MEMORANDUM

DATE: December 9, 2021

RE: Punchlist Items
Sigma, LLC
11 Washington Place East
Section 122.12, Block 4, Lot 26 & 408

11 WASHINGTON PLACE EAST

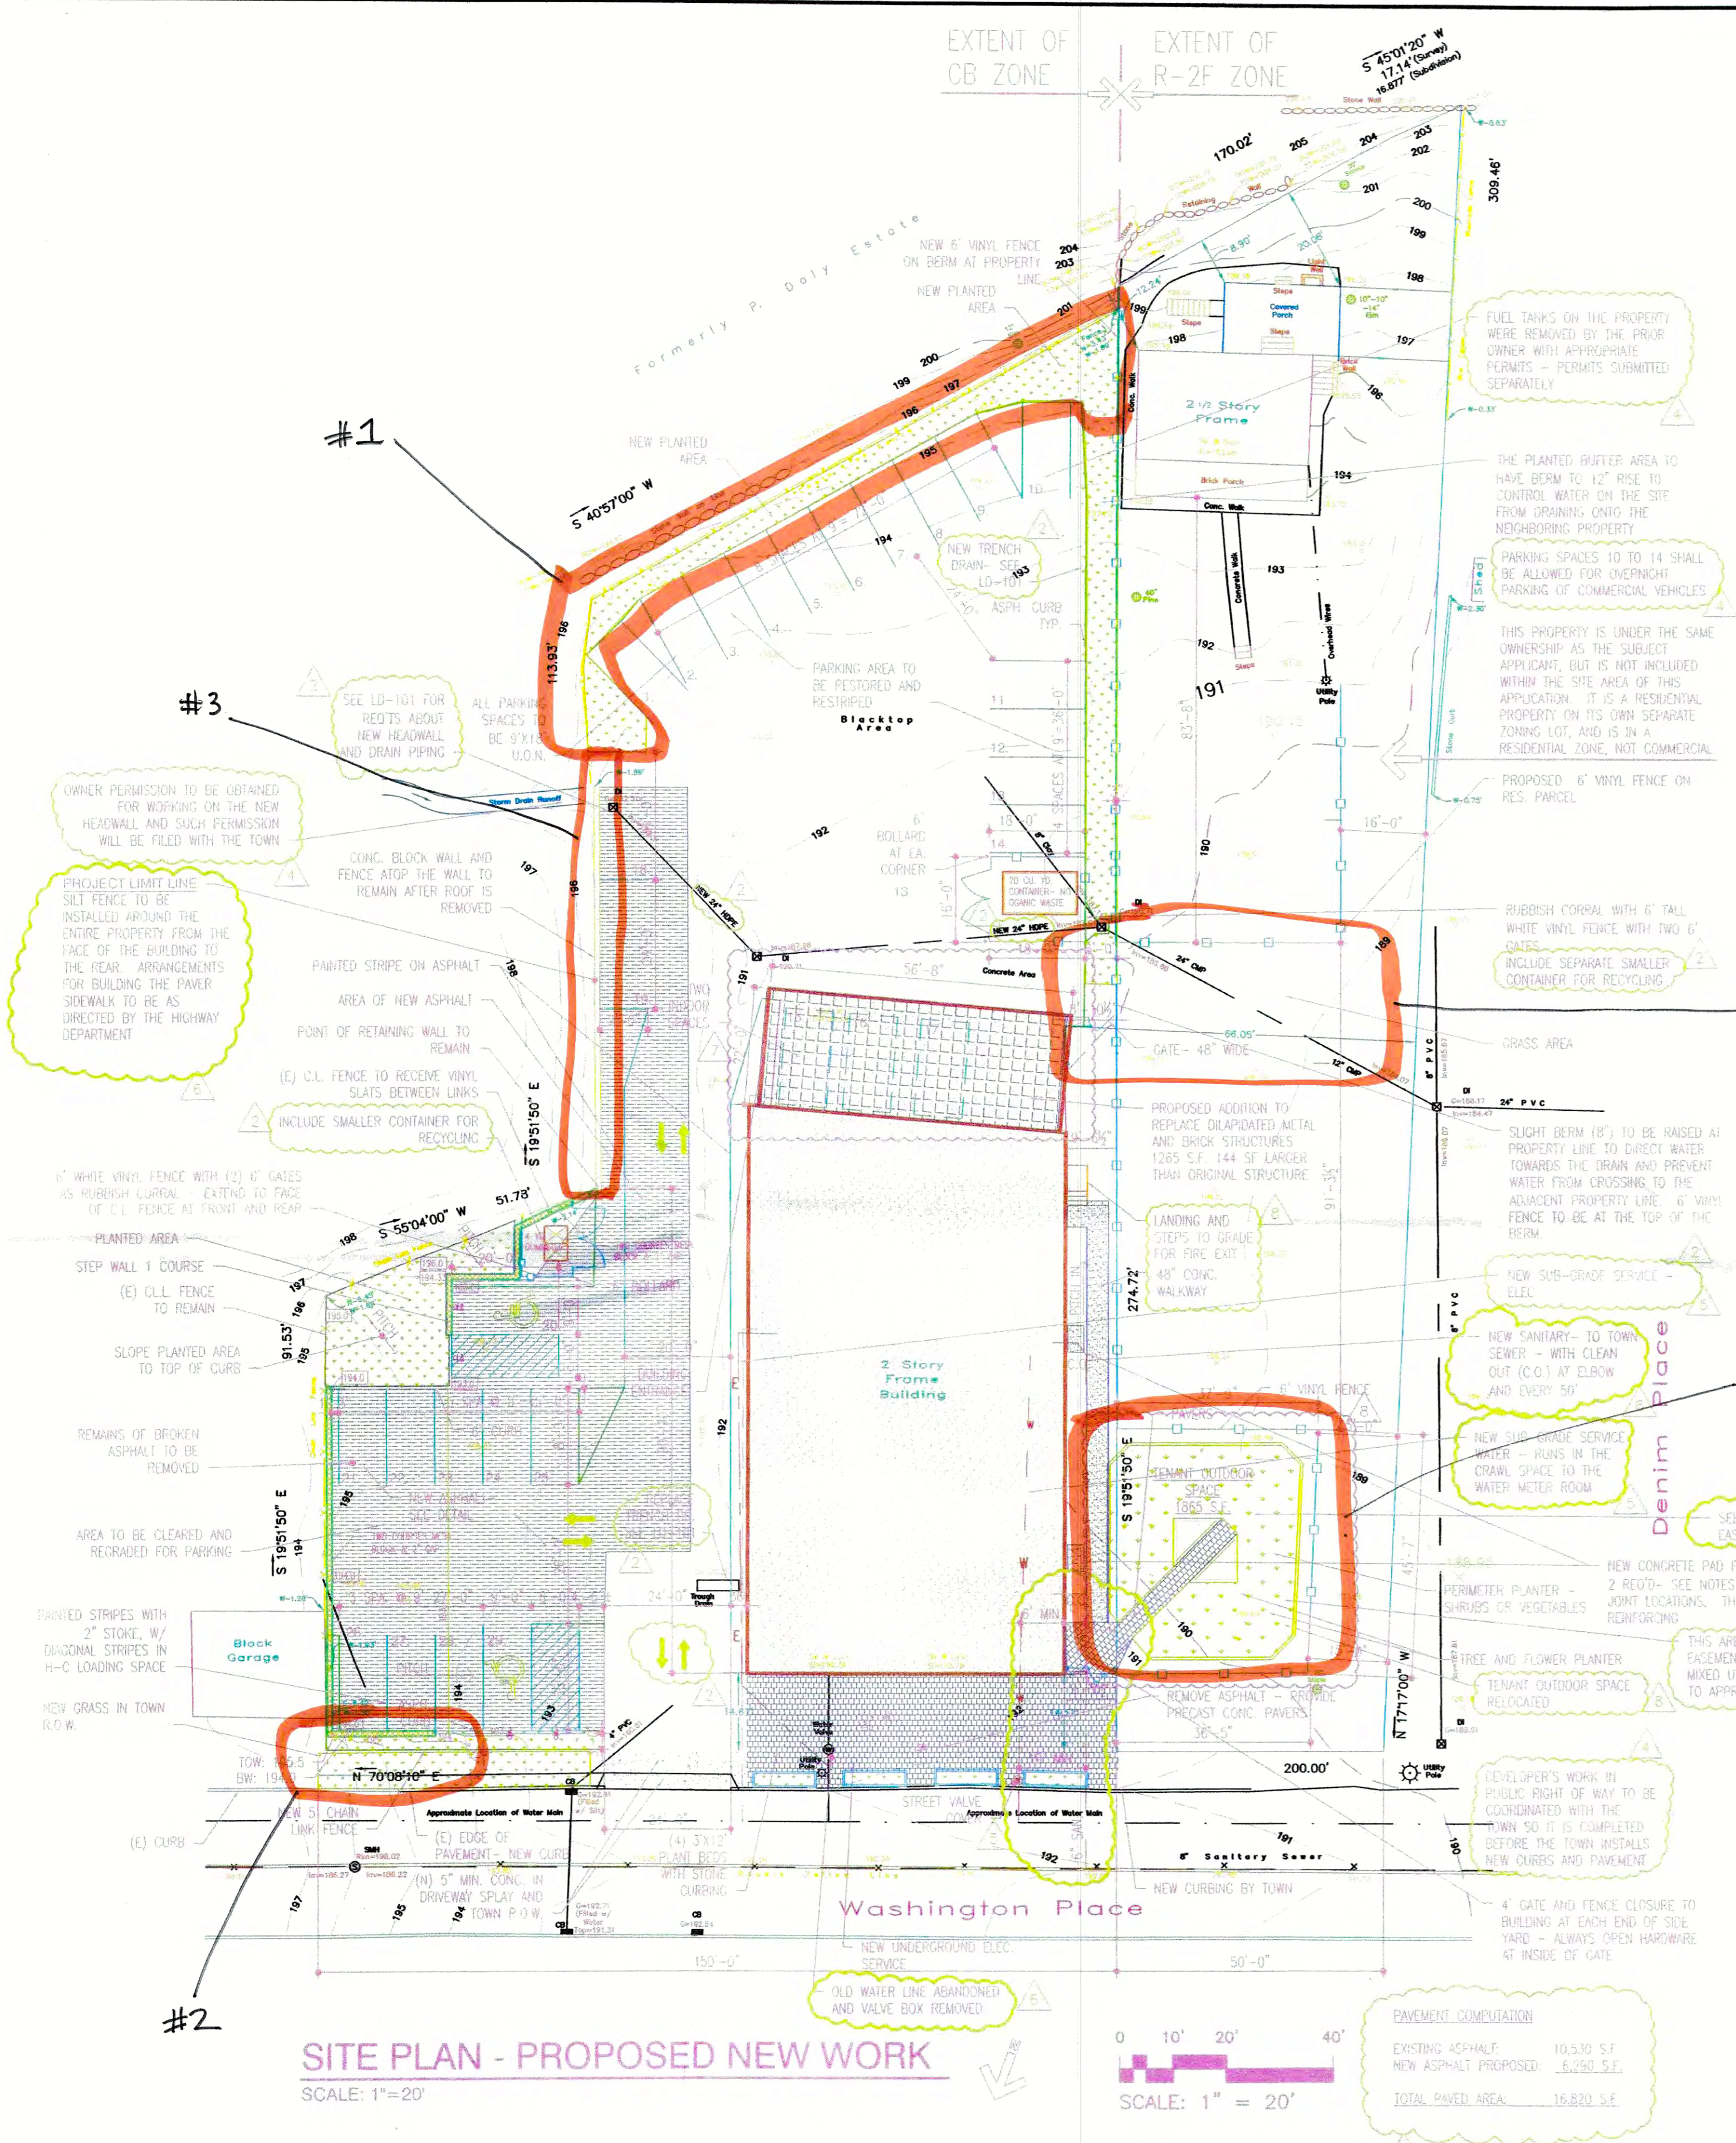
1. The planting buffer at the rear of the parking lot has been removed and a three (3) foot high concrete block wall constructed to retain the hillside. The asphalt parking lot was extended to the block wall (see attached Photo #1).

2. A proposed retaining wall was not built within the northeast corner along the property frontage and adjacent to the neighboring property/garage. Final site grading resulted in the wall not being required (see attached Photo #2).

3. A retaining wall was proposed along the east side of the property. A two-tiered wall was built instead. These walls were constructed at half the height of the proposed wall. The upper wall was constructed on the neighboring property, while the lower wall was constructed at the same location on the applicant's site as the original single wall (see attached Photo #3).

4. The recreation area which was approved as green space was constructed with a concrete pad. This was changed due to maintenance issues (see attached Photo #4).

5. The fencing on the west side of the building and recreation area was changed, providing a larger fenced yard (see attached Photo #5).
